# Town of Hilton Head Island Regular Design Review Board Meeting

# CONSTRUCTION DOCUMENT PACKAGE FOR THE TOWN OF HILTON HEAD ISLAND ROWING AND SAILING CENTER

## DESIGN TEAM/DRB COMMENT SHEET

PROJECT NAME: TOHH Rowing & Sailing Center – NEW DEVELOPMENT  
FINAL REVIEW

DATE  
05-01-2013  
PROJECT NUMBER  
01-12033  
SHEET TITLE  
Keynote  
Plan  
SHEET NUMBER  
**L1**

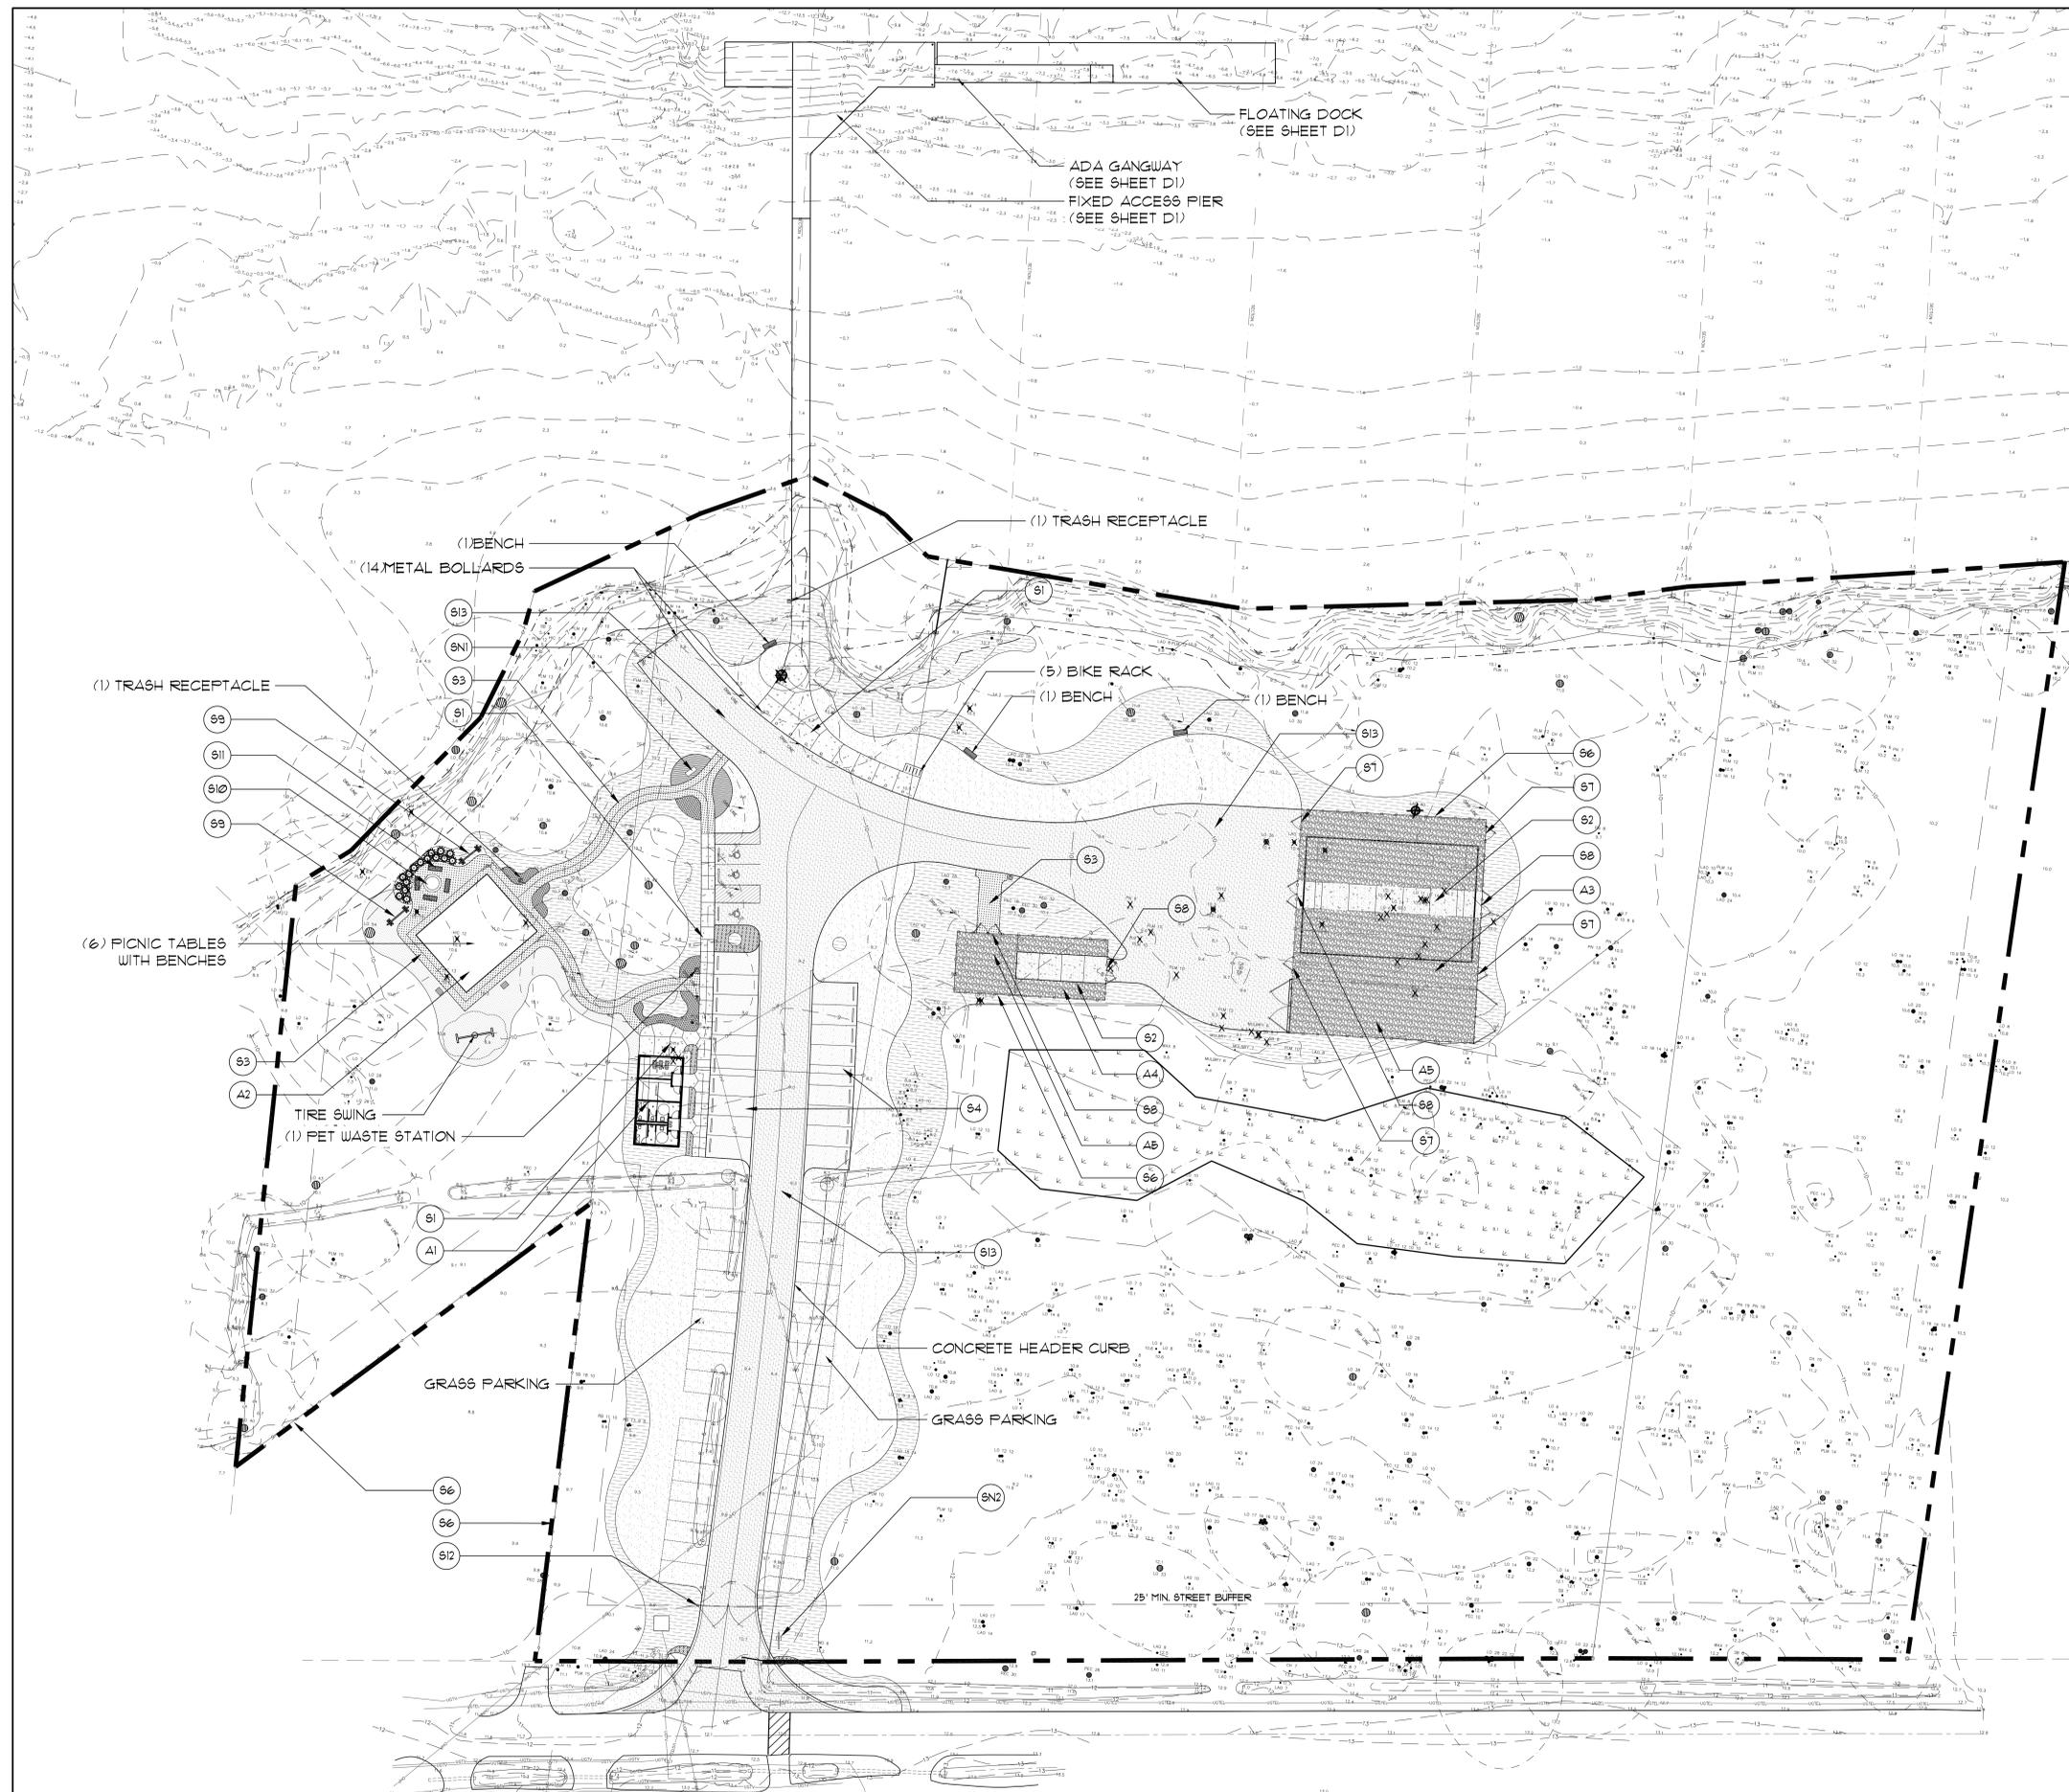
Proposed pavilion and bath house/storage buildings are located within canopy of several specimen/significant trees. Efforts should be taken to minimize impact to trees. Staff will meet with Applicant on-site to discuss options.
Plan proposes to remove two specimen trees. One tree is known to be dead/dying. Removal of other tree (laurel oak at storage area) will require variance or identification of tree as dead/dying.

**PAVILION**  
**A.2**

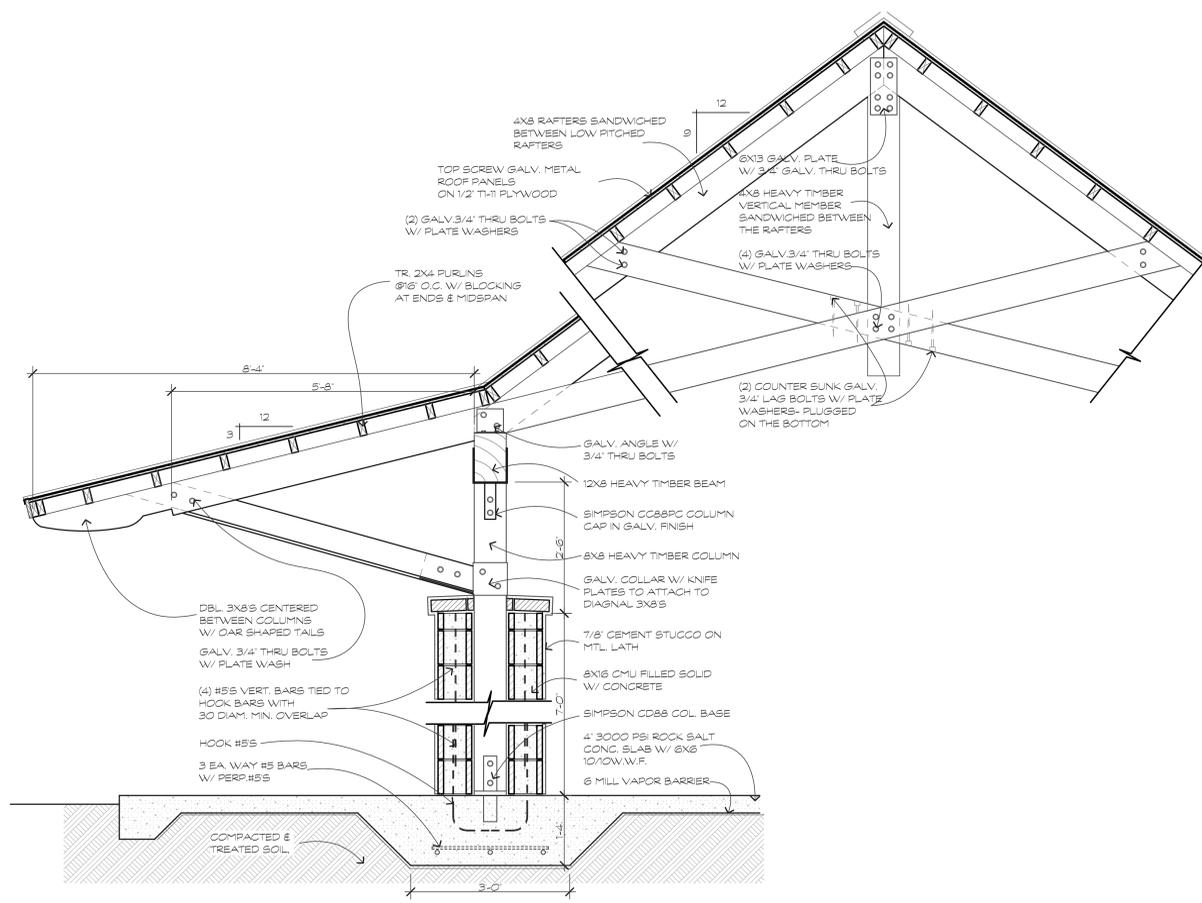
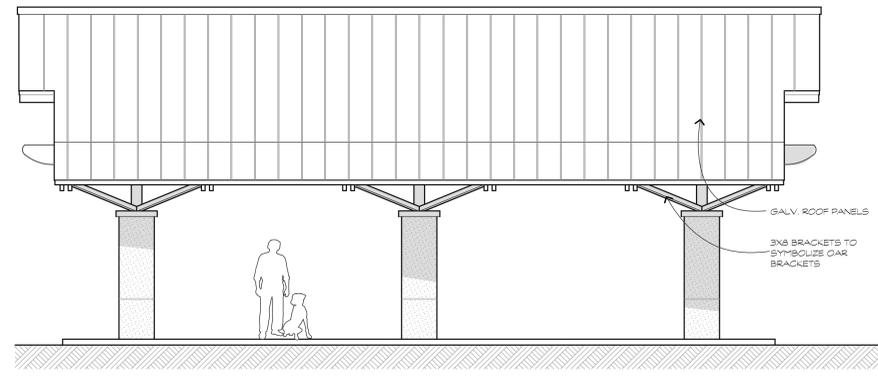
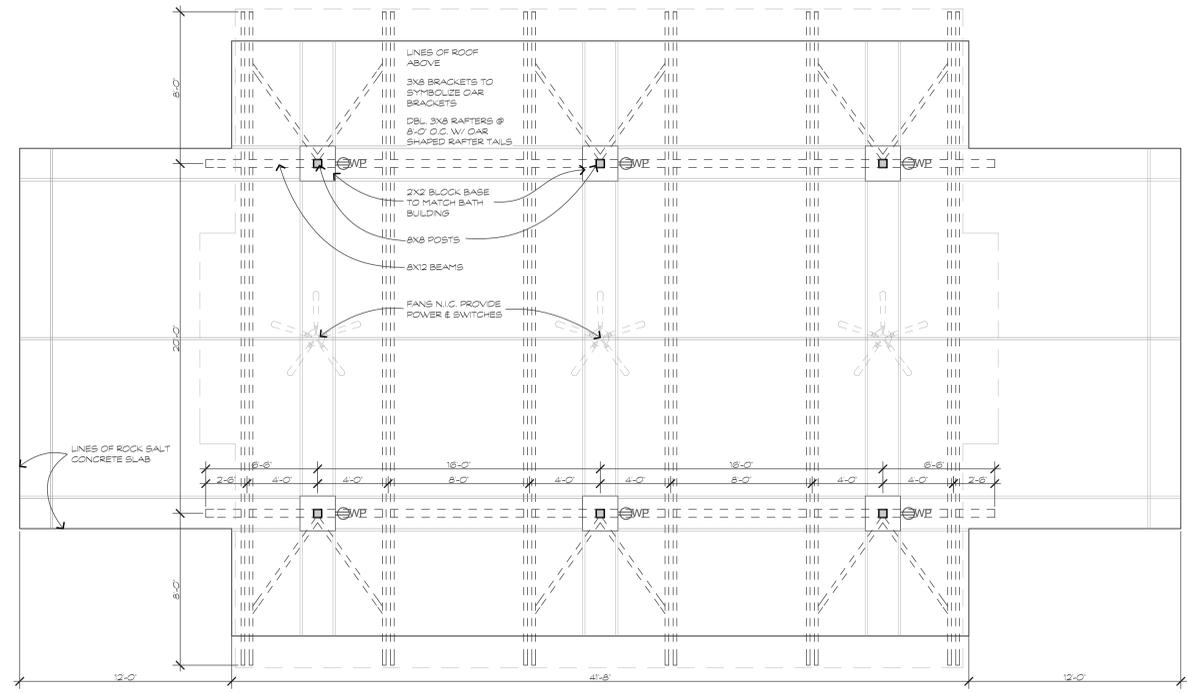
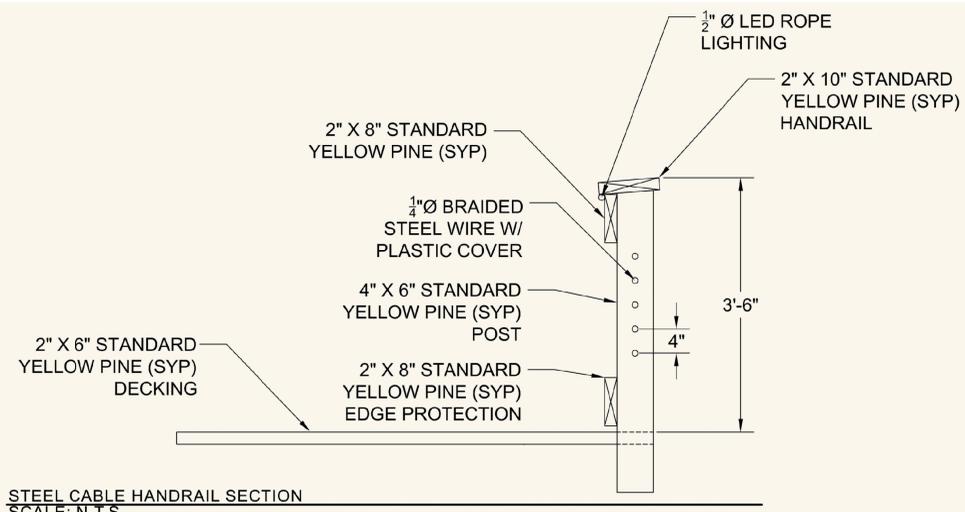
Decorative lighting is limited and low wattage and adds to the visual character	<input type="checkbox"/>	<input type="checkbox"/>	<input checked="" type="checkbox"/>	None shown.
Accessory elements are design to coordinate with the primary structure	<input checked="" type="checkbox"/>	<input type="checkbox"/>	<input type="checkbox"/>	Picnic Pavilion will match character of Bath House building in appearance and materials.
